ESSEX COUNTY
STORMWATER SYSTEM RECONSTRUCTION
AES PROJECT NO. 4270

ADDENDUM NUMBER 2

DATE: December 16, 2014
PROJECT: Stormwater System Reconstruction
AES PROJECT NO: 4270
OWNER: Essex County
ENGINEER: AES Northeast, PLLC
TO: Prospective Bidders/Plan Holders

Narrative Summary: Replaces Drawing.
DRAWING C-501 – DETAILS
Delete: In its Entirety.
Insert: Drawing C-501 – DETAILS, dated 12/16/14 Per Addendum No. 2.

1 TYP. UTILITY MAIN TRENCH
 SCALE: 3/4" = 1'-0"

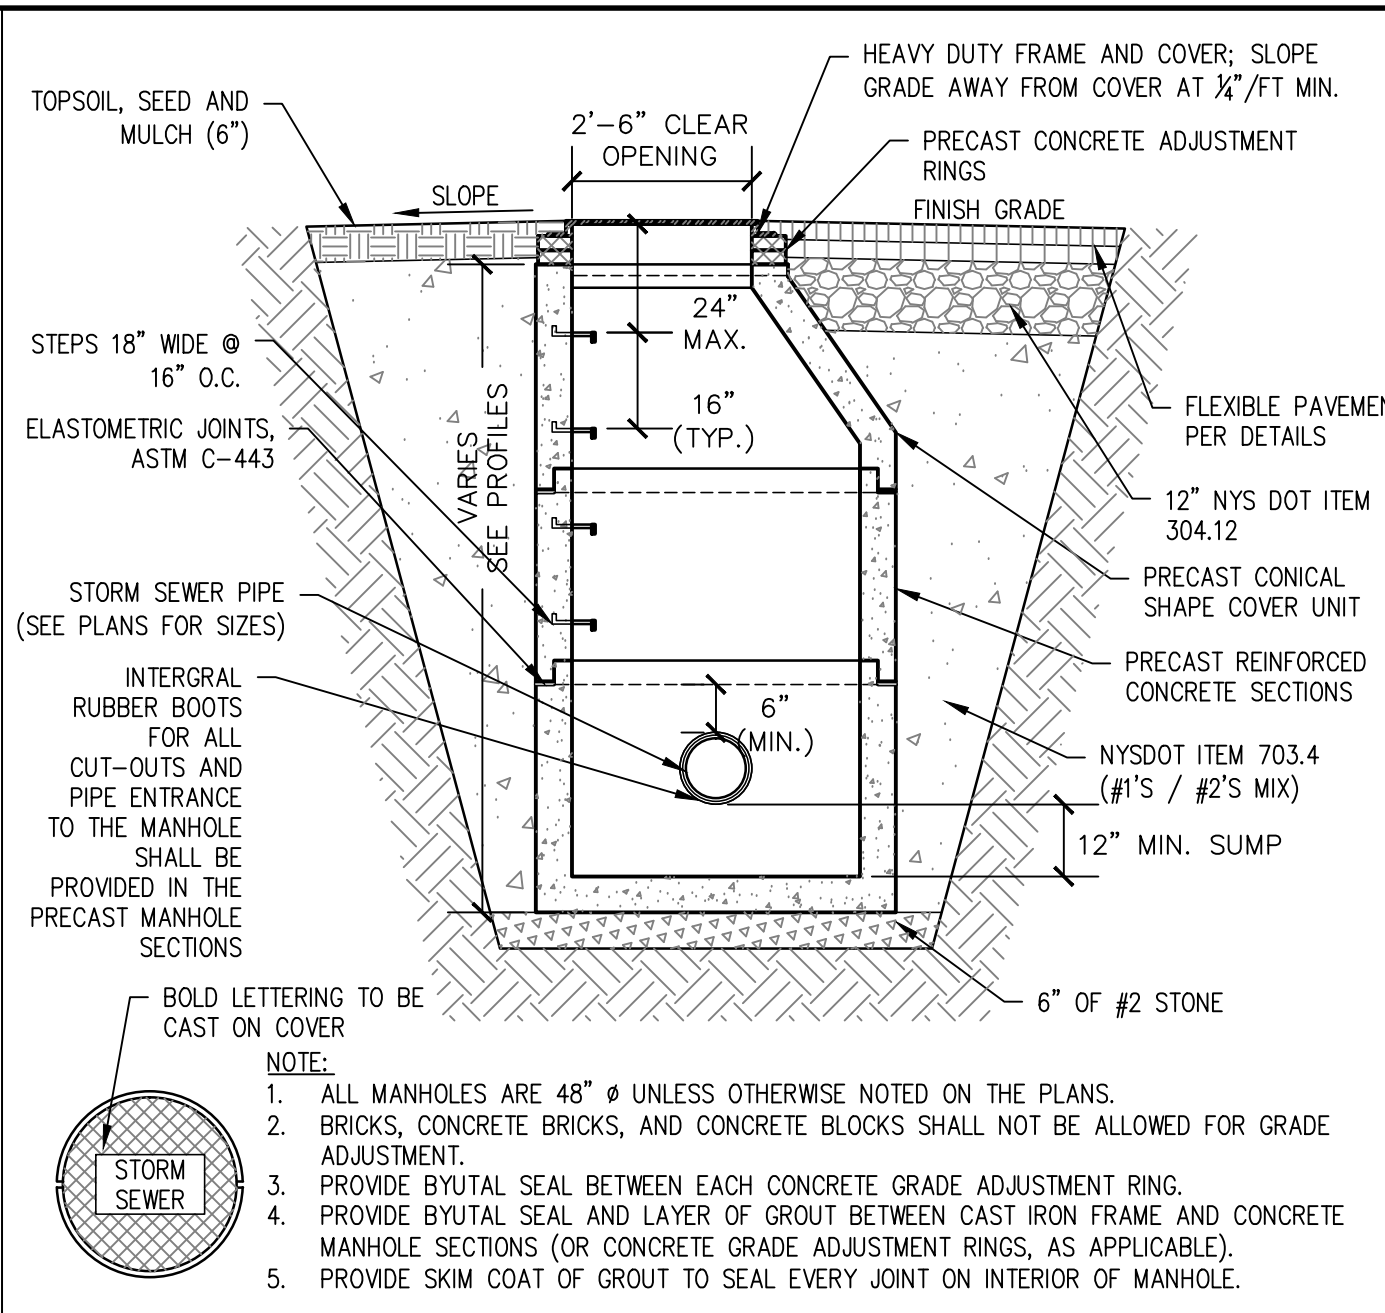
Question No. 4 Is aircraft locator cable required for these HDPE pipes? The utility trench detail 1/C501 states it is not required if structures are present. The Structures Details (2/C501 and 5/C501) both reference connecting the tracer cable to the manhole cover. Please clarify.

Question No. 5 Utility Trench Detail 1/C501 depicts #1/#2 Stone Backfill. The notes reference utilizing suitable excavated material as backfill under the base pipe installation unit, with payment for select granular fill if imported material is required. We assume the same goes for the #1/#2 stone unit. Please Clarify.

Question No. 14 Is pipe wrap required? 1/C501?

ANSWER: Sheet C-501 has been revised. The aircraft locator cable will not be required for this project.

ANSWER: Excavated soils will not be reused for this project. Sheet C-501 has been revised.

ANSWER: **Sheet C-501 has been revised. The pipe wrap previously mentioned in 1/C-501 will not be required.**

2 STORM SEWER MANHOLE
 SCALE: 3/8" = 1'-0"

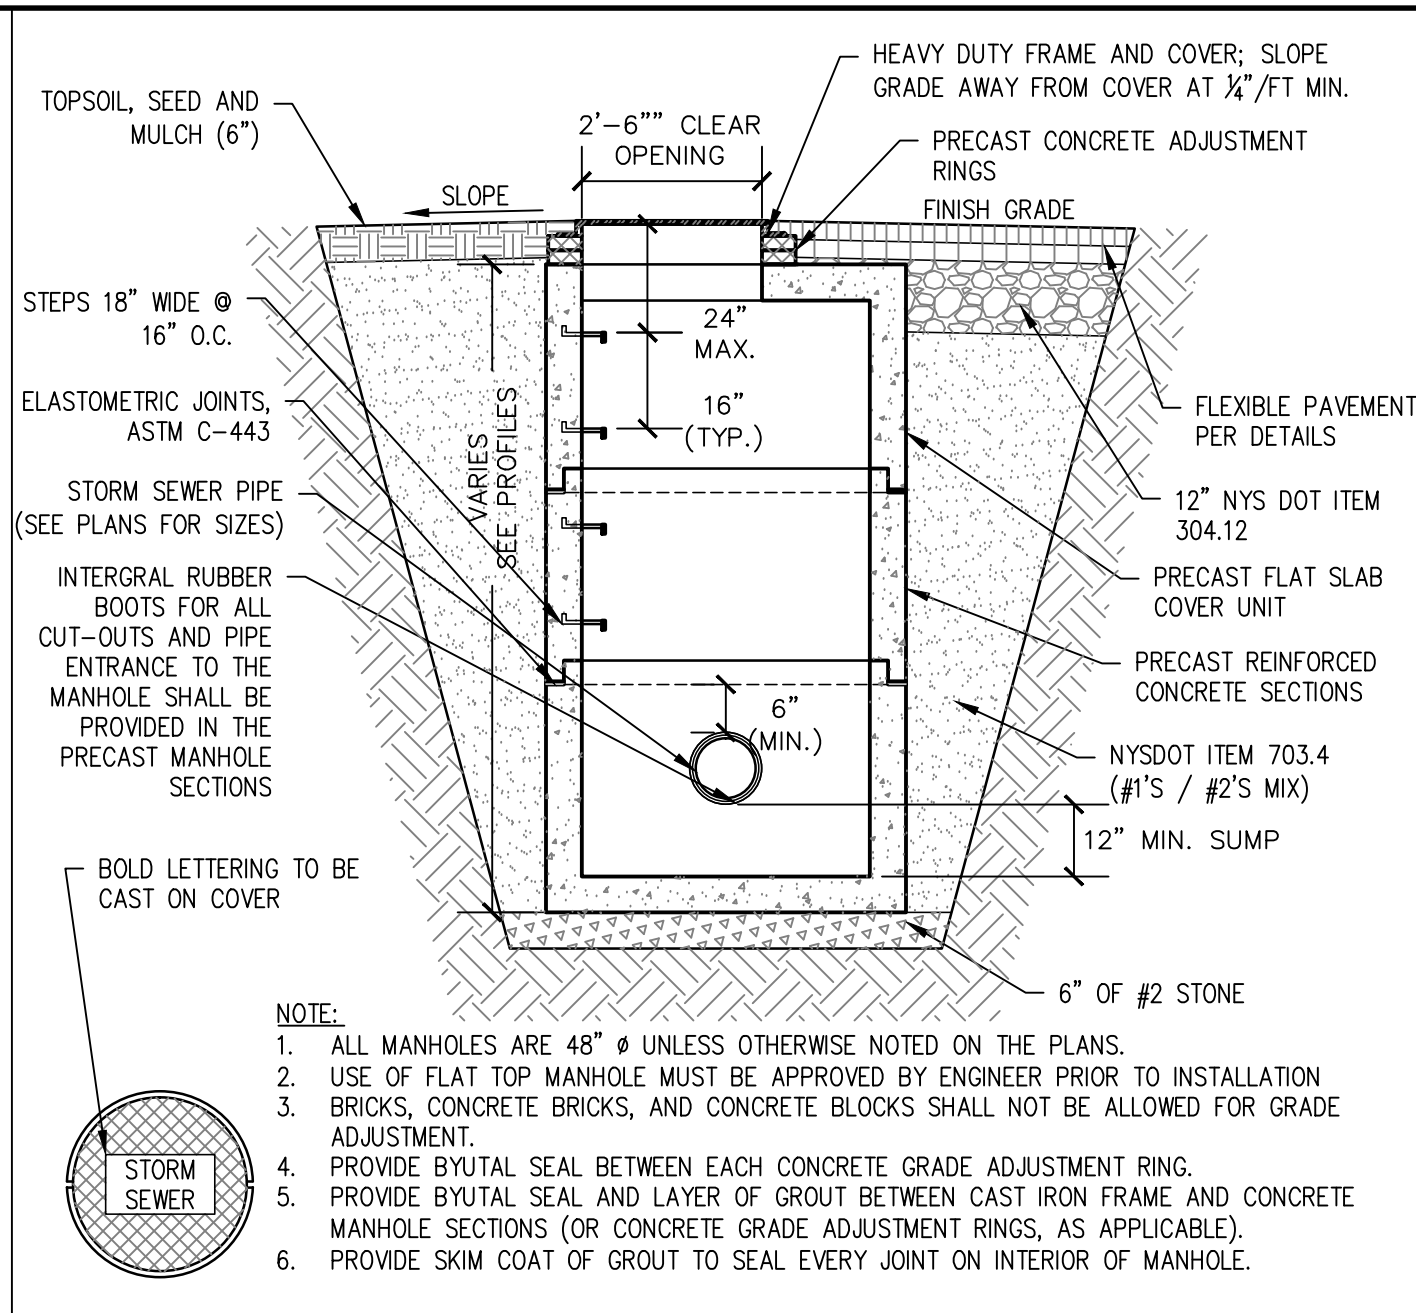
Question No. 6 Manhole Details (2/C501) and Catch Basin Detail (5/C501) depict the use of select granular fill. We assume that suitable onsite material is to be incorporated into the bid unit (similar to the HDPE) and imported select granular will be paid for under its separate bid item, if required. Please advise.

ANSWER: Excavated soils will not be reused for this project. Sheet C-501 has been revised. NYSDOT Item 703.4 (#1's / #2's) will be used for backfill around manholes and catch basins.
